REVISED LANDSCAPE PLAN
THE PREVIOUS LANDSCAPE PLAN HAS BEEN REVISED.
THE CHANGES ARE AS FOLLOWS:

LOT 14,
BLOCK SEVEN,
COUNTRY WEST SUBDIVISION,
LARAMIE COUNTY, WYOMING.

COUNTRY WEST SUBDIVISION
BRUSO HOMES

LANDSCAPE PLAN

L1

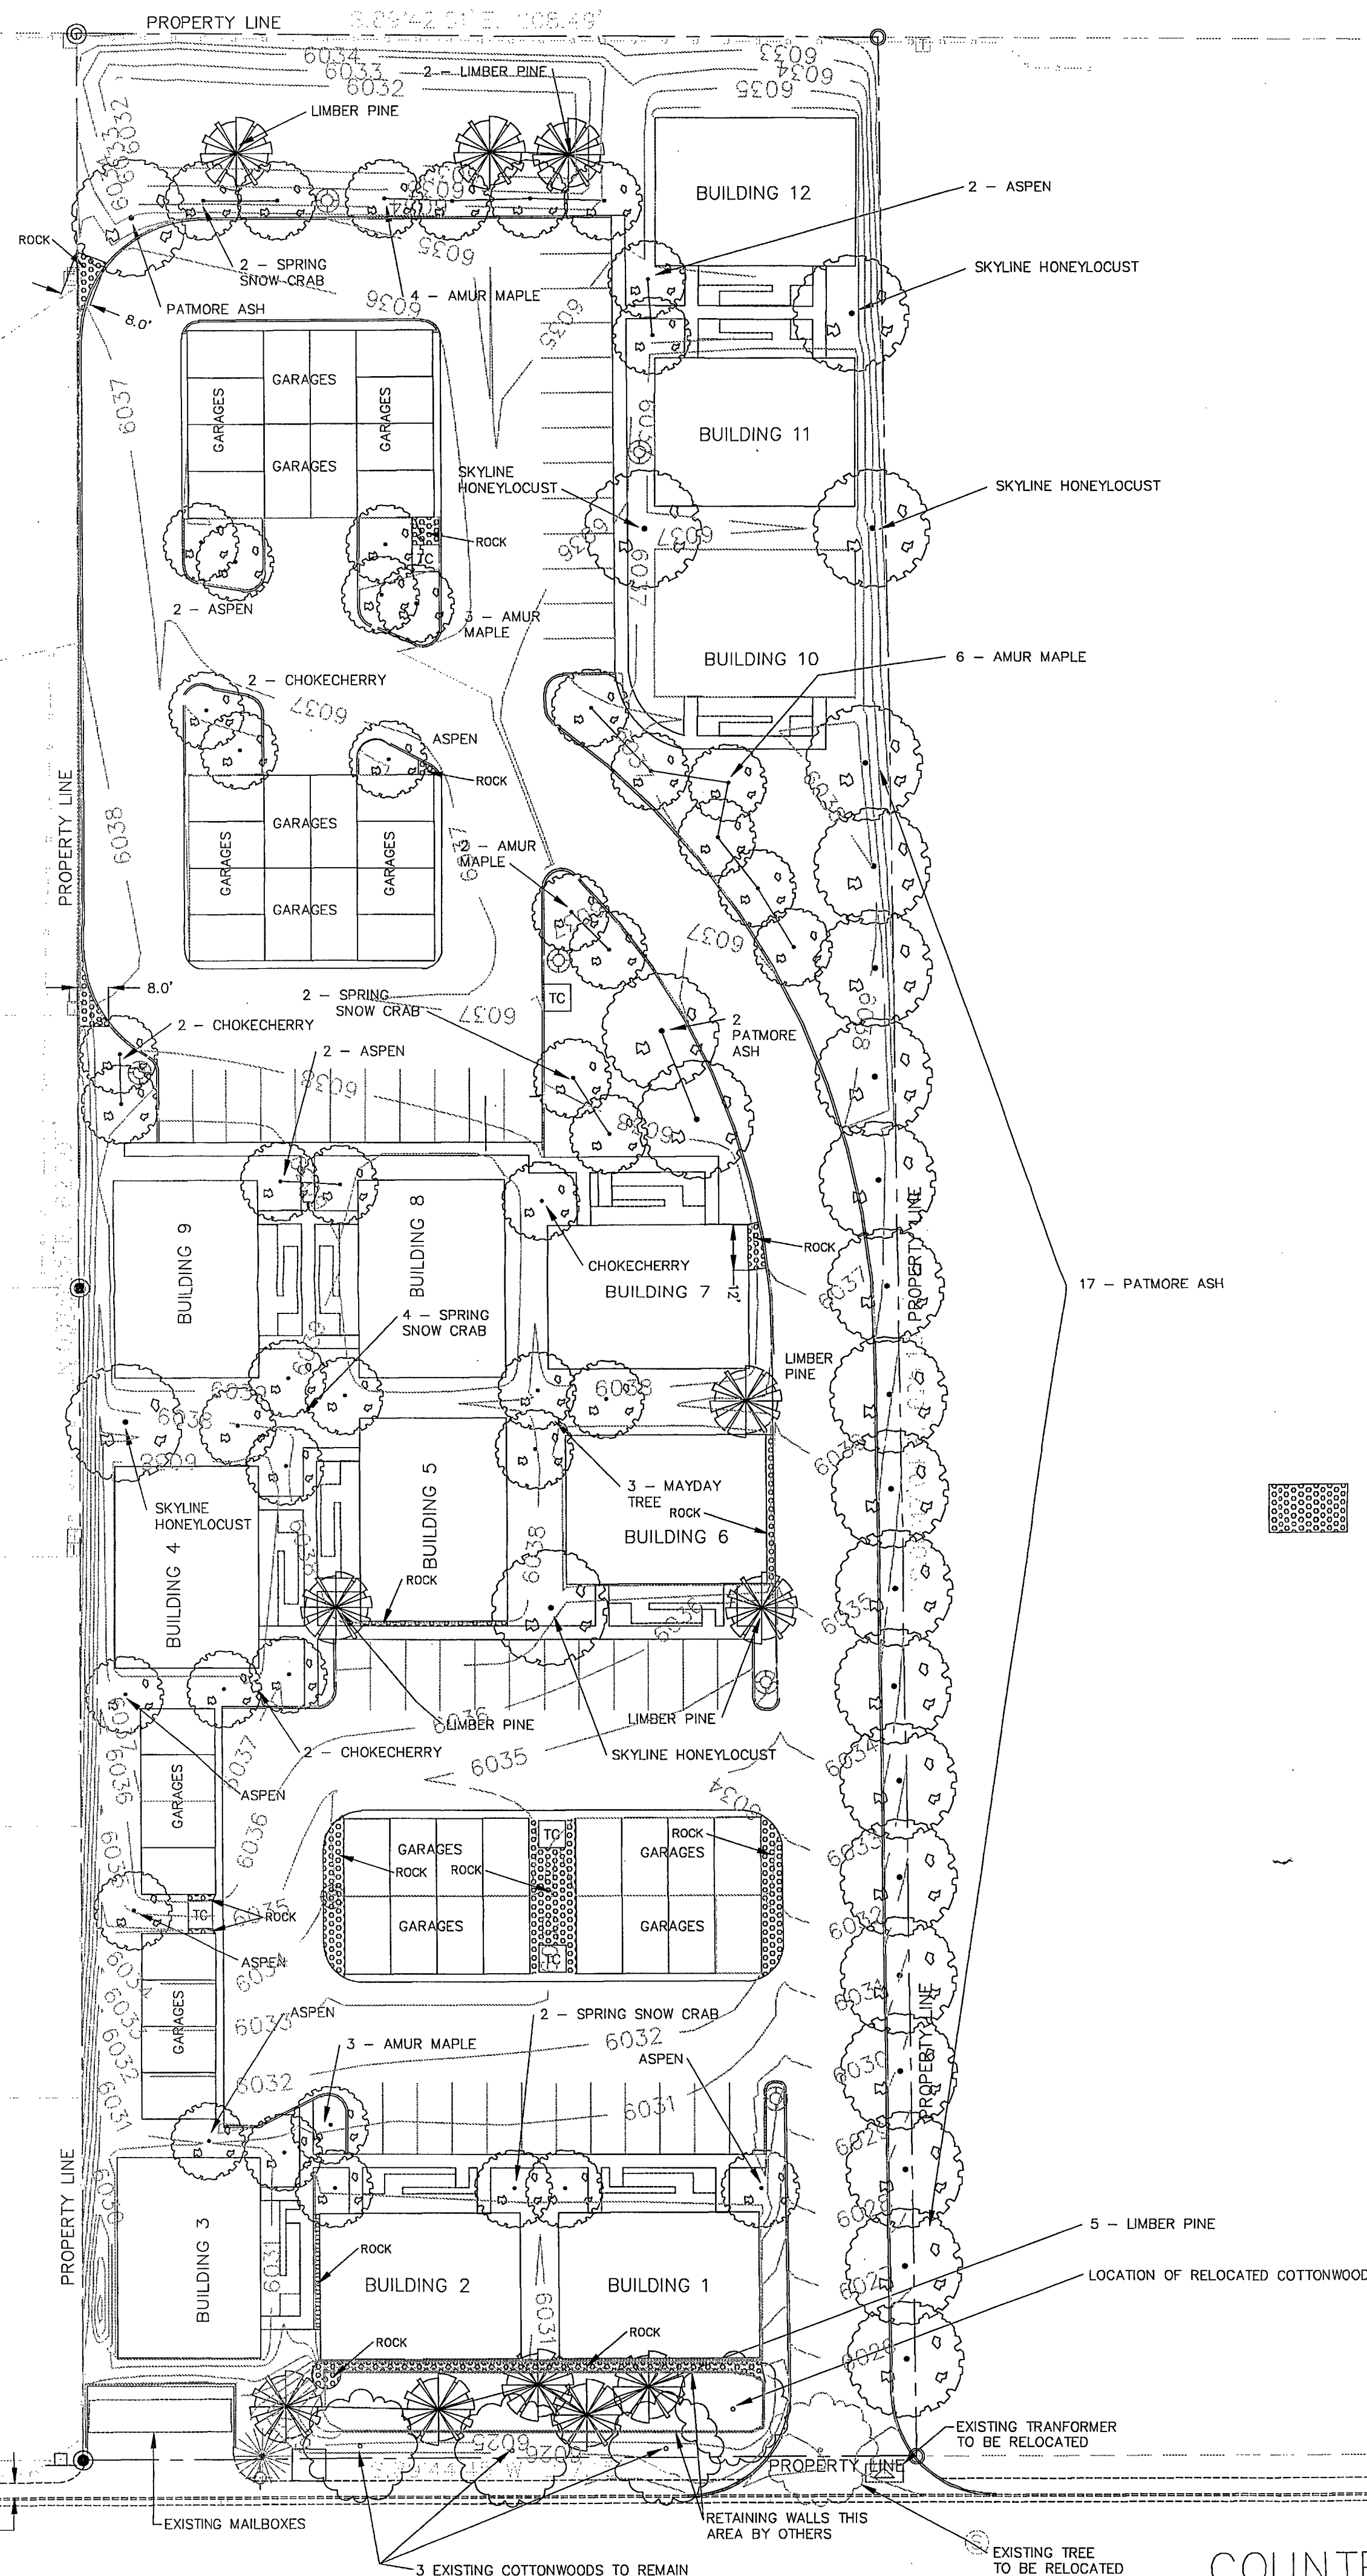
1. ROCK MULCH AREAS WITH WEED BARRIER AND STEEL EDGER HAVE BEEN ADDED AS SHOWN.
 2. SEEDED AREAS WILL BE REDUCED THE AMOUNT OF THE ROCK MULCH AREAS.
- NO CHANGES TO PLANTINGS HAVE BEEN MADE.

NOTE: ALL AREAS SHOWN ON THE DRAWING AS ROCK MULCH AREAS SHALL HAVE 3" DEEP ROCK MULCH OVER WEED BARRIER.
ALL PERIMETER EDGES OF THE ROCK MULCH AREAS NOT FORMED BY CONCRETE OR BUILDINGS SHALL BE EDGED WITH 4" BLACK STEEL EDGER INSTALLED PER MANUFACTURER'S SPECIFICATIONS.

ROCK MULCH SHALL BE 3/4"-1" WASHED RIVER ROCK UNLESS OTHER ROCK IS SELECTED BY OWNER.
